MEMORANDUM

To: Planning and Zoning Commission
From: David C. Gertsch, AICP, Planning Director
Date: July 5, 2023
Re: Zoning Resolution Amendment, Aquifer Protection Overlay Zone

Attachment 1. Amended APOZ Map

Attachment 2. Stantec Recommendations for Amendments to the APOZ

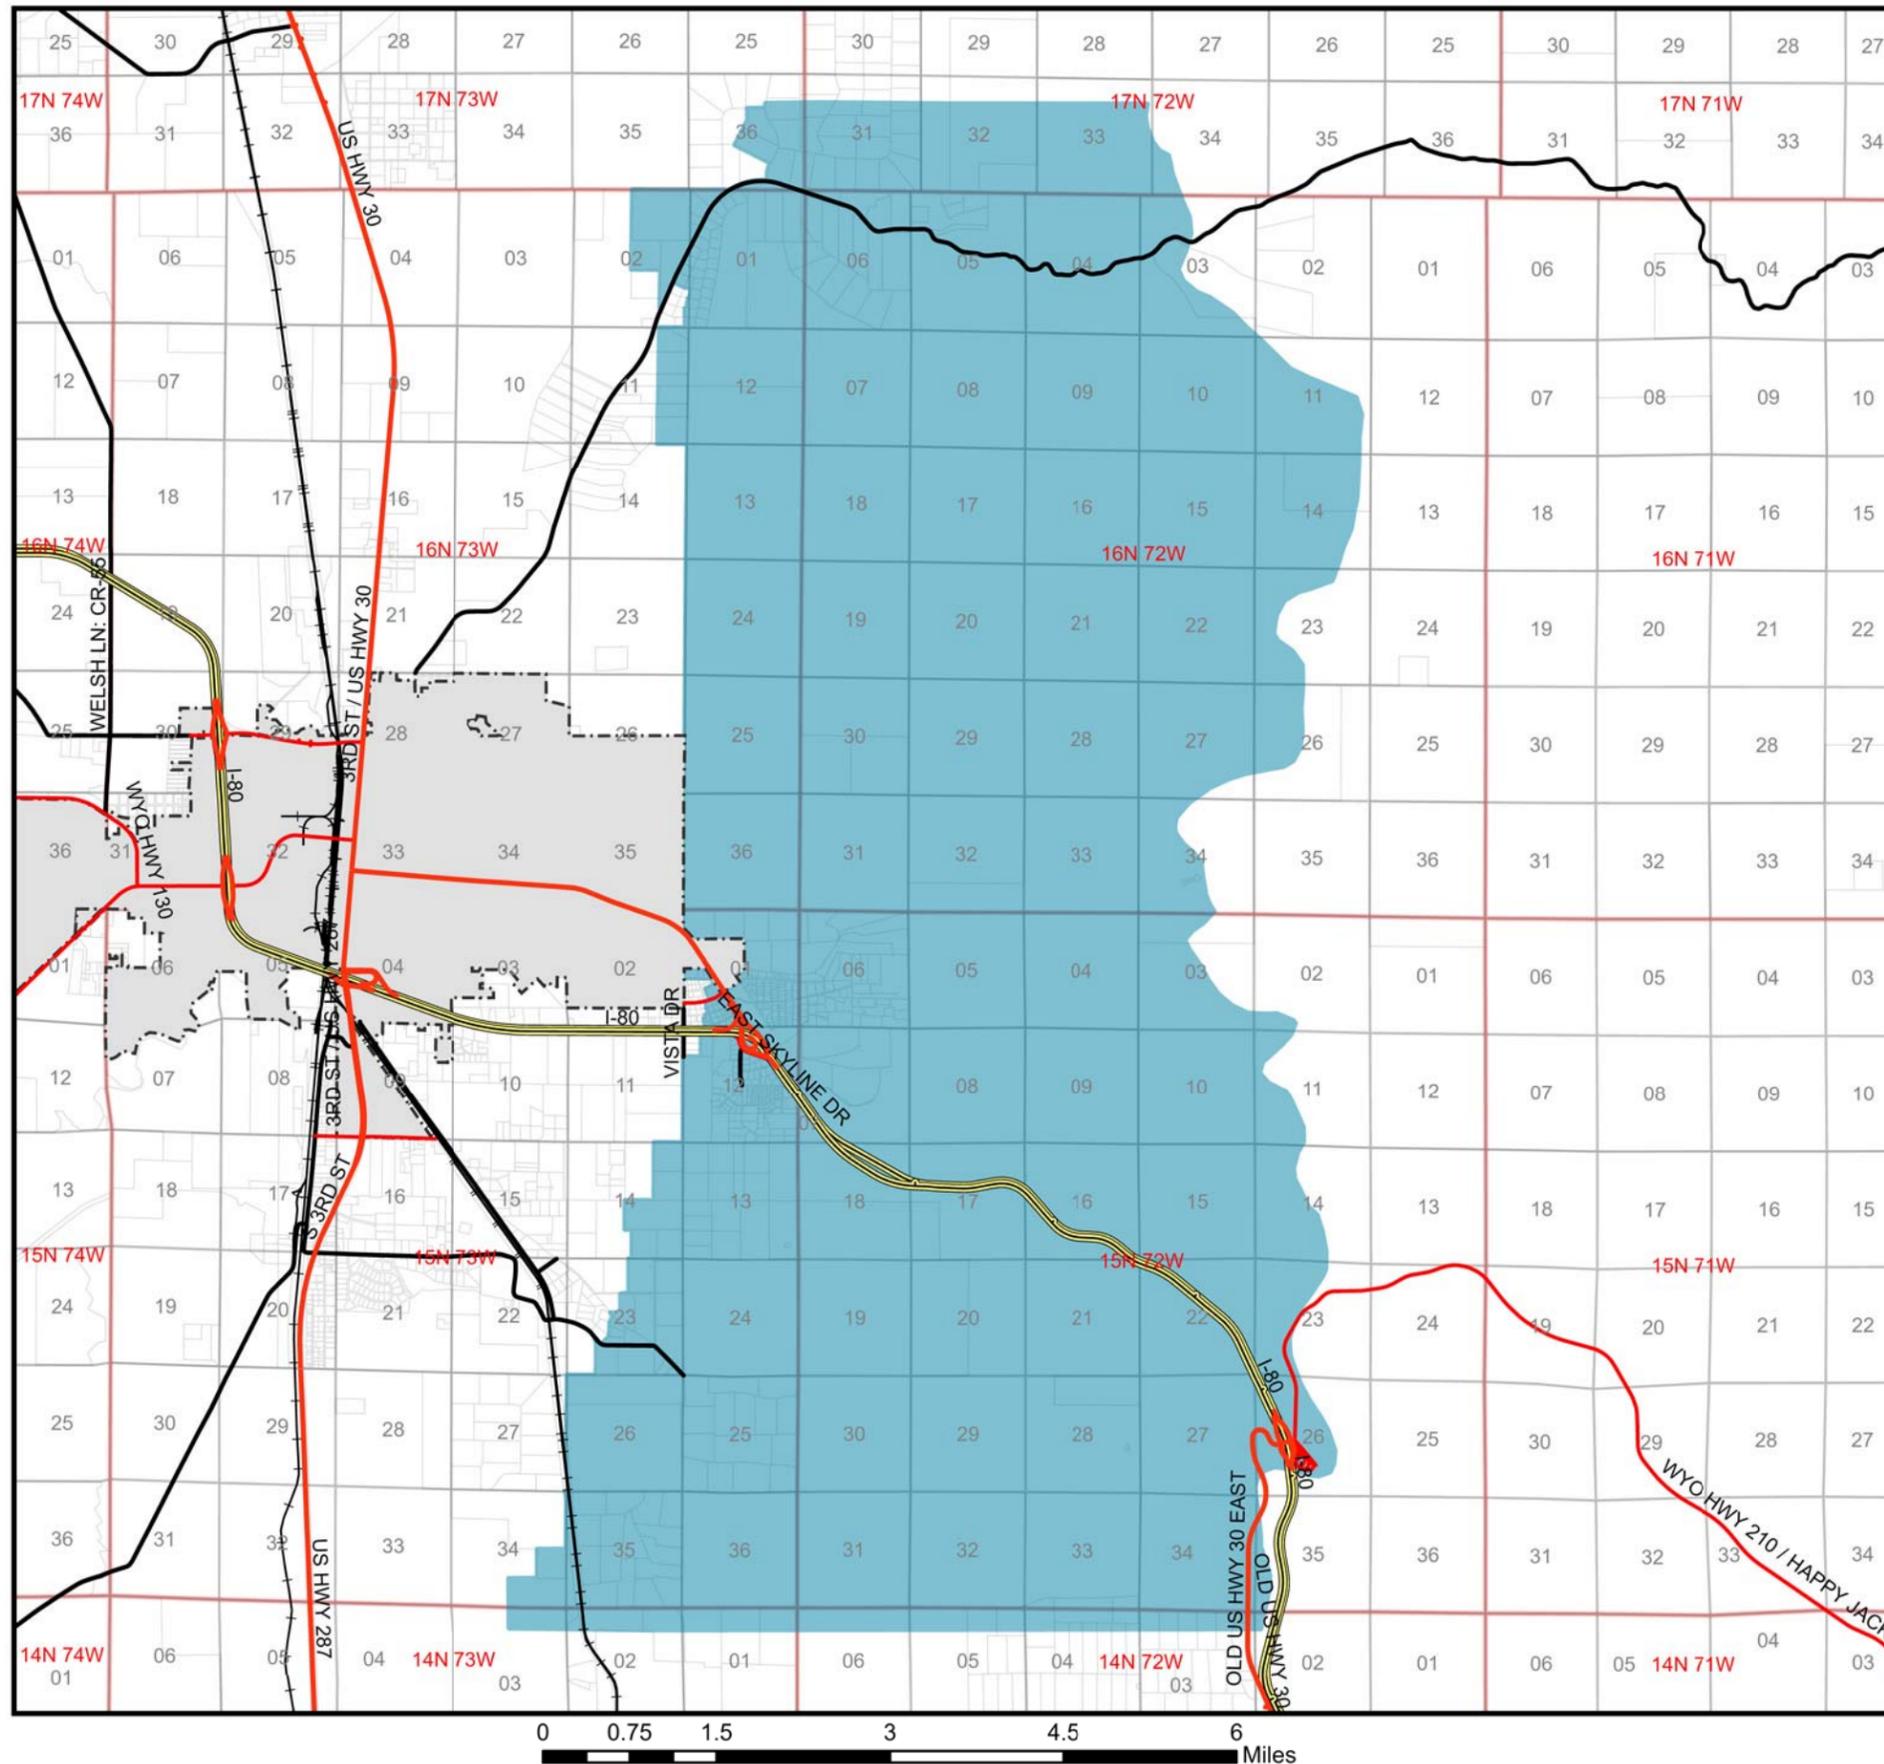
I have created a new map using the boundary recommended in the plan. The north, east, and south boundaries, for the most part have not been modified. The western boundary has been redrawn to follow property lines and other surveyed lines just west of the “Protective Satanka Shale Thickness” line created by Stantec. The Protective Satanka Shale Thickness line is a line estimating where there is 75 feet of protective Satanka Shale thickness over the Casper Aquifer. This line was delineated using well logs on file with the Wyoming State Engineer’s Office and other geologic features to help determine whether there is 75 feet of protective Satanka Shale thickness over the Casper Aquifer and other adjustments based on the best information that was available. The proposed western boundary considers the need for some buffer from the Protective Satanka Shale Thickness line because the exact location of 75 feet of Satanka Shale thickness is not known. The proposed western boundary is intended to provide the needed protection from contamination to the aquifer.
